MEMORANDUM

Adequate Public Facilities (APF) Review

Wheaton Hills, Building #4

APF200801

Wheaton Hills, Building #4 Attachment 1: Site Plan

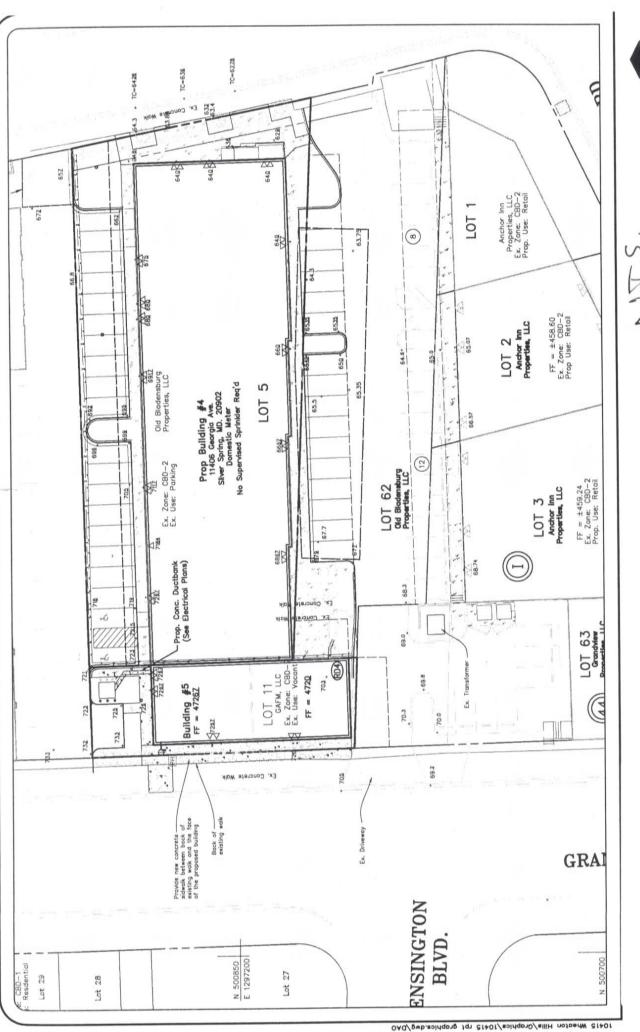
The subject site is located on the west side of Georgia Avenue (MD 97), approximately 100 feet north of University Boulevard West (MD 193) as shown in Figure 1. Currently the site is vacant. The applicant is proposing to construct a commercial/retail building (Attachment 2, site plan). The proposed building will consist of 12,353 square feet of retail use located on existing Lot 5, Block 44 in Wheaton.

- 1) The applicant must limit the future building permit to 12,353 square-foot commercial/retail.
- Prior to the release of a building permit, the applicant must supply a copy of a DPS permit for construction within the ROW to the building permit coordinator for the following to meet the PAMR requirements:
 - Construct an ADA ramp for the east/west movement of Reedie Drive and Bucknell Drive on the southern side.

Construct an ADA ramp for the east/west movement of Grandview Avenue and Kensington Boulevard on the north end.
